PROJECT: CAPTIVE POWER PLANT (CPP) PACKAGE
VISAKH REFINERY MODERNIZATION PROJECT (VRMP)
JOB NO. B016

DEPT. PE&SD CODE.	UNTOQL DIMS. OR C/M/F	SCALE	WEIGHT (KG)	REF. TO ASSY. DRG.	ITEM NO.	NO.OF ITEMS
450				--N.A.--	--N.A.--	--N.A.--
TITLE: SWITCHGEAR ROOM EQUIPMENT LAYOUT (SS-93)				CARD CODE: N.A.	BHEL DRG NO. PY-LE-1-M104-2019-01	REV. 01
				SHT. No 01	NO. OF SHT. 02

BHEL's reply to EIL/HPCL comments

EIL Job No	B016
EIL Transmission Document No	
Document No	PY-LE-1-M104-2019-01 (2 Sheets) Equipment Layout SS 93
Review Code	2

PLAN AT EL.100.000 M LEVEL FOR 66Kv & 33 Kv GIS BUILDING

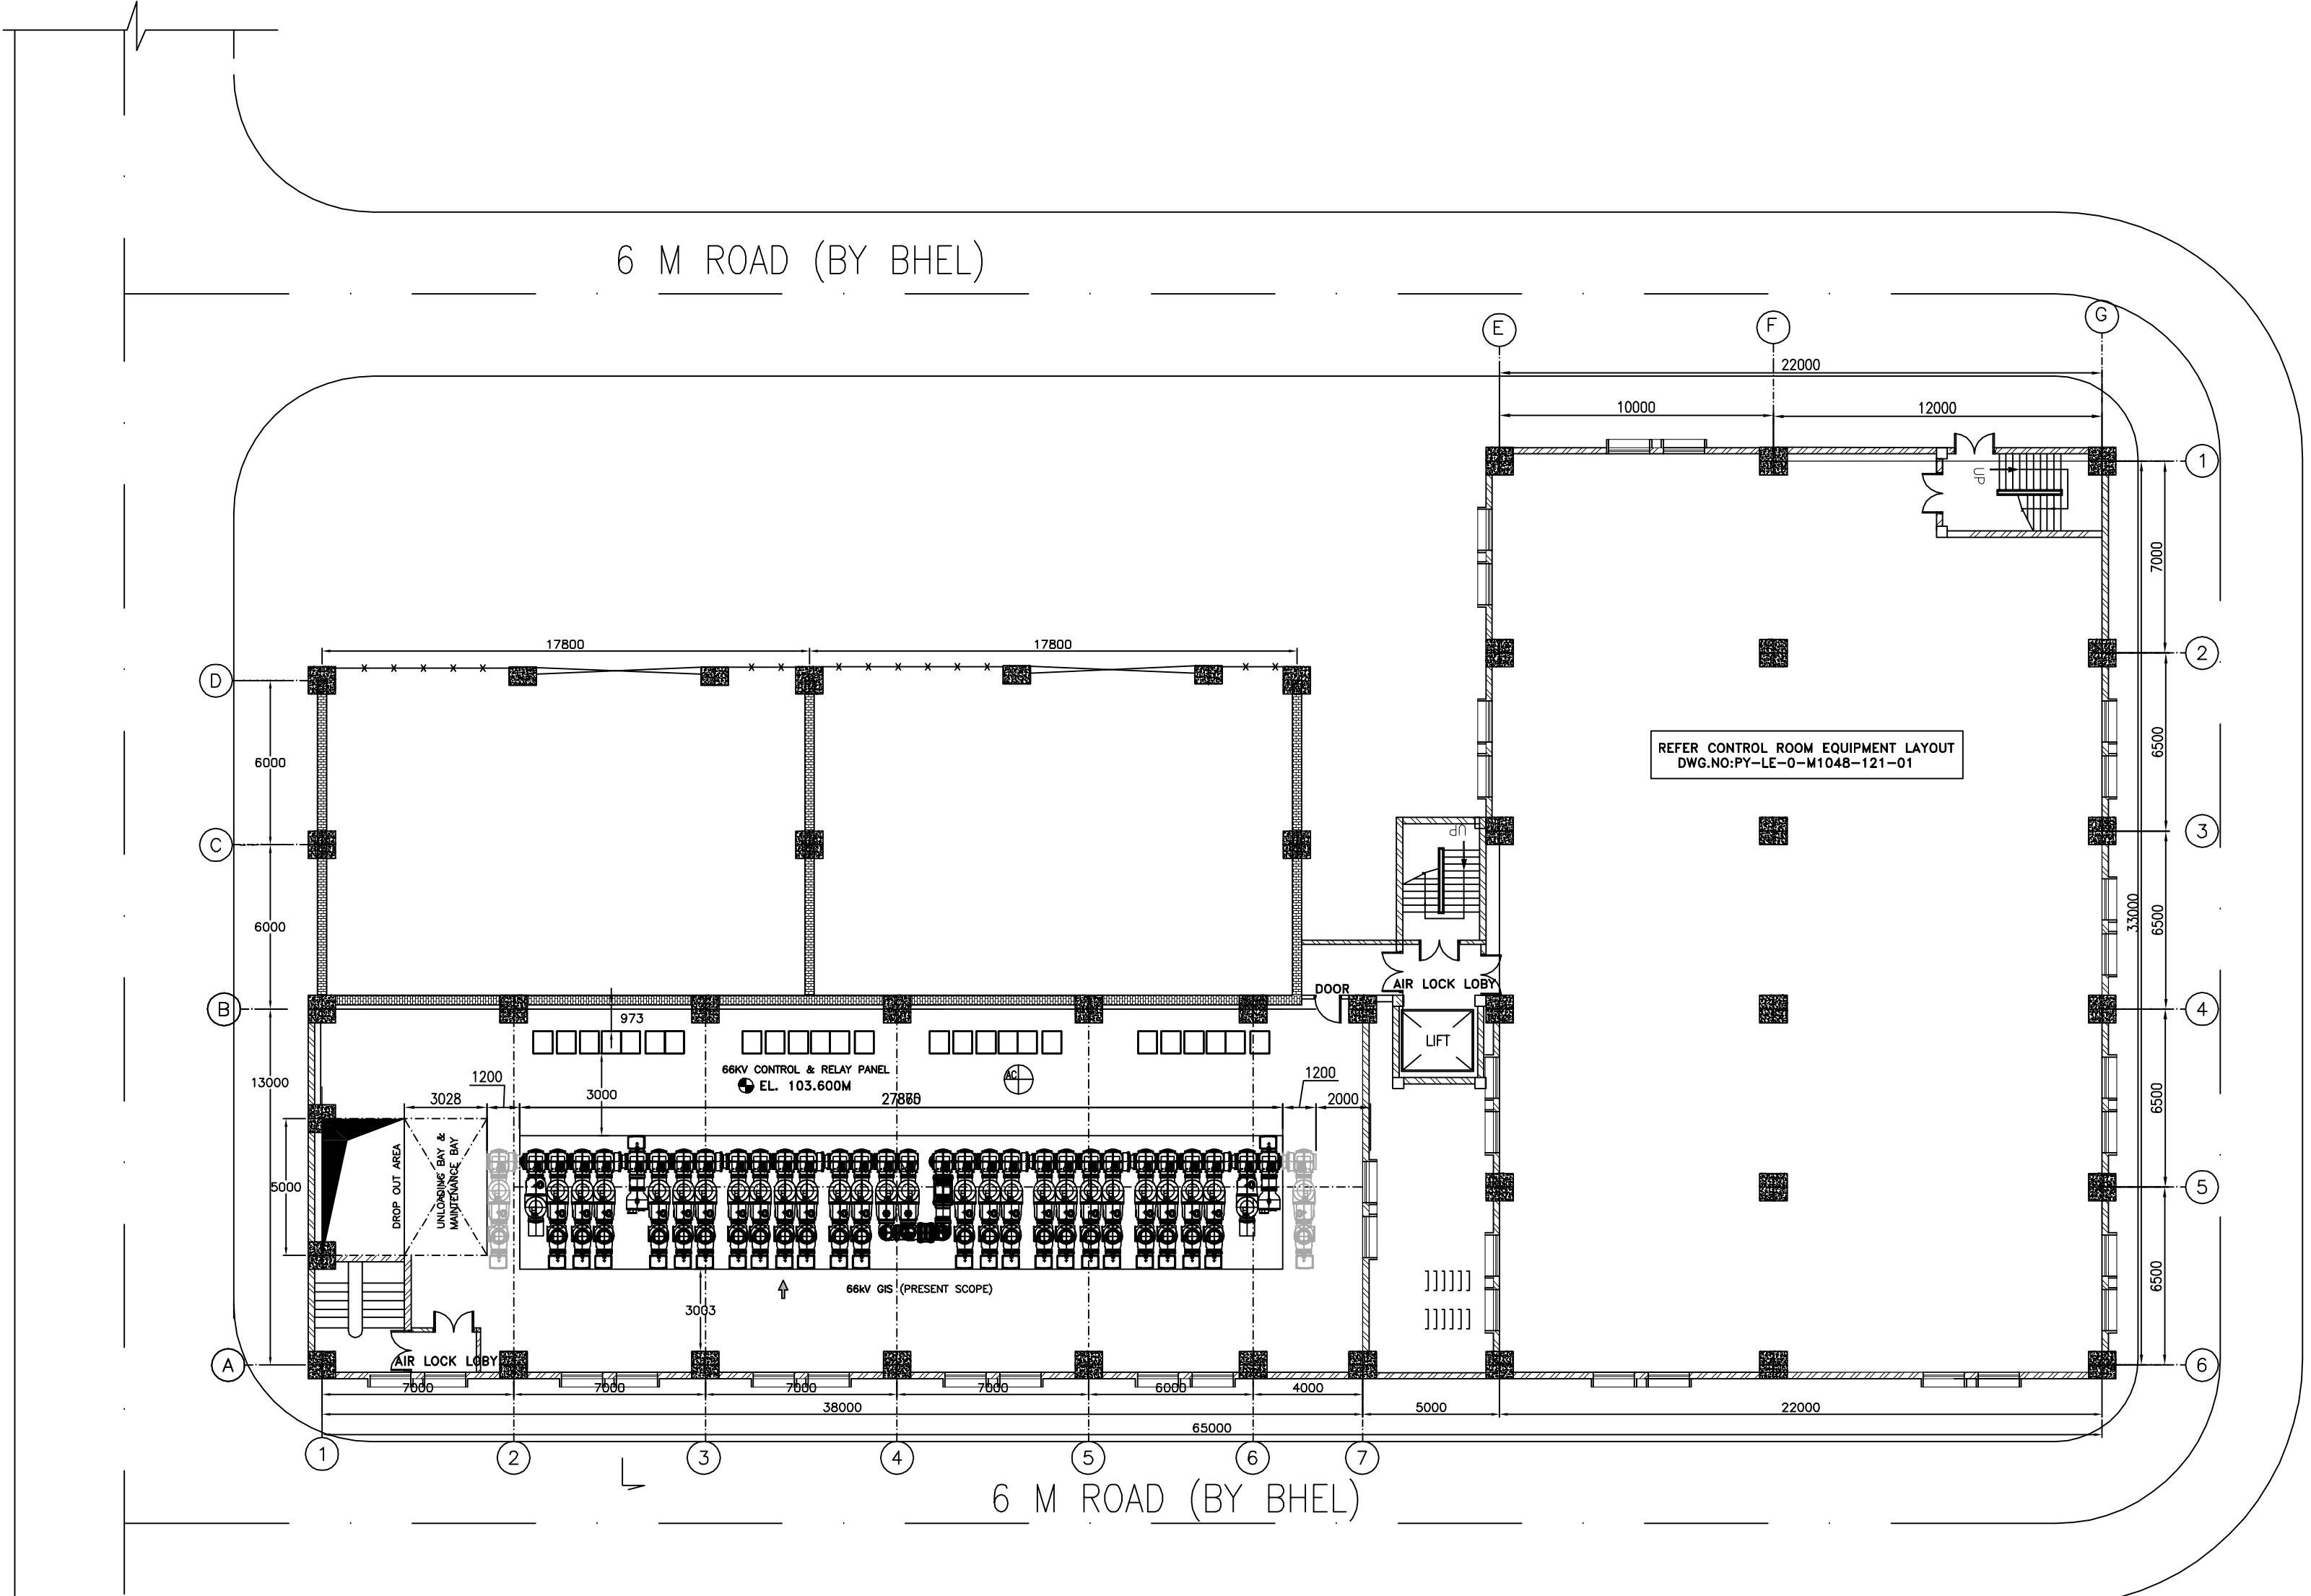
1.1	Indicate the 220/66kV power transformer dimensions and all around clearances available. Indicate the NIFPS system of the 220/66kV power transformers.	Noted and incorporated in the revised layout drawing

1.2	Lift may be relocated to the northside.	Lift position is fixed by taking care entry into 66kV GIS building and 33kV GIS building.
1.3	Cable cellar can be extended upto the control room to utilize the unused space between lift and the cable trays.	Noted.
	<u>At elevation EL. 103.600 M level</u>

PLAN AT EL.103.600 M LEVEL FOR 66Kv & 33 Kv GIS BUILDING

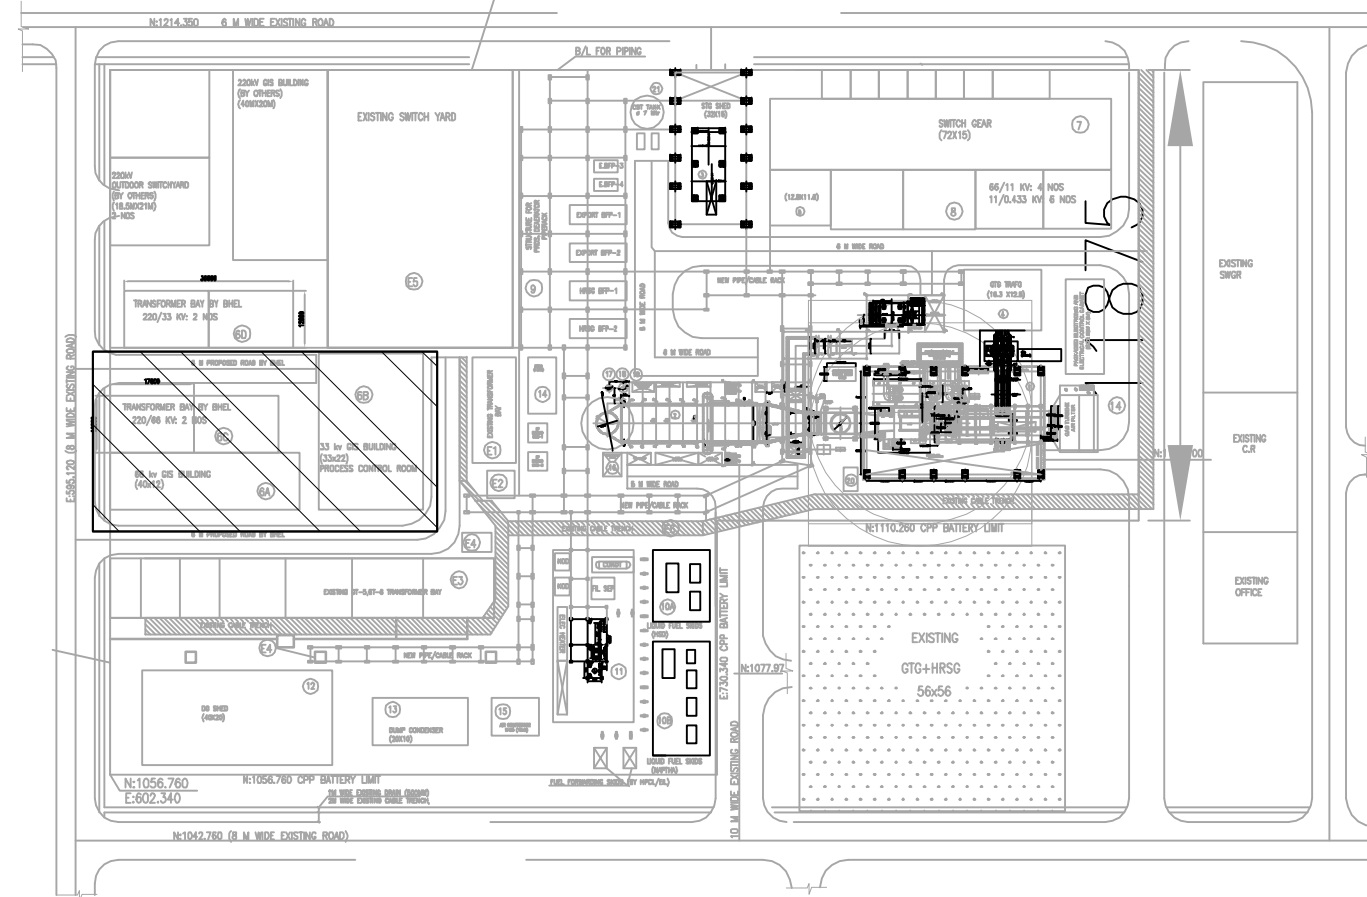
1.4	Indicate the loading / unloading area.	Noted and incorporated in revised equipment layout
1.5	Clarify the extent of coverage of EOT crane above 66kV GIS.	Noted and same will be indicated in the architectural drawings.

1.6	Mono rail shall be provided in the loading / unloading area.	Noted and incorporated in the revised equipment layout
1.7	Airlock lobby shall be provided for entry into the GIS hall.	Noted and incorporated in the revised equipment layout

1.8	Indicate the equipment entry door.	Noted and indicated revised layout
1.9	Show wall on west side of the GIS air conditioned hall.	
1.10	66kV GIS switchgear hall shall be sized considering 2 future GIS bays on each side with minimum 2M clearances from future bays to wall. Minimum size of 66kV GIS switchgear room shall be 42M.	1 future bay each side of the 66kV GIS is considered as per standard philosophy.

1.11	Please check whether CRP panels require rear maintenance. If required, minimum 1M rear access shall be provided.	Noted.
1.12	GIS switchgear hall shall be extended upto control room building to utilize the unused space between lift and the cable trays.	Noted
	<u>At elevation EL. 105.500 M level</u>
